CHANGE ORDER NUMBER: 4

Project: 22IFB139

Roadway: FM 3349

**Change Order No. 4**

~~FM 3349 HUTTO 16" WATER MAIN  
RELOCATION~~

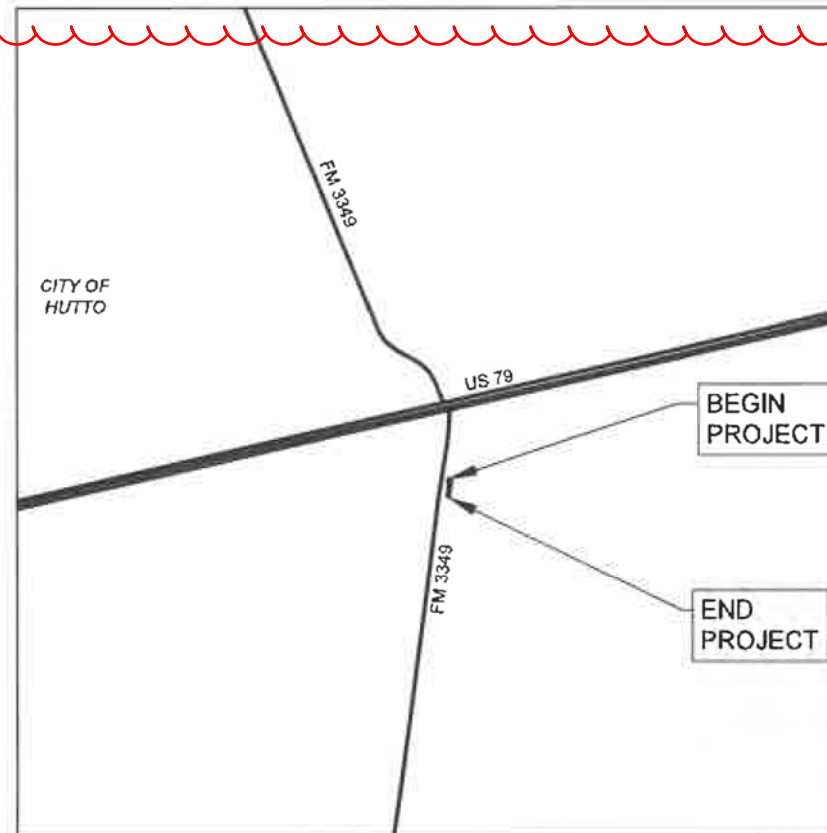
REMOVE PLAN  
SET IN ITS  
ENTIRETY
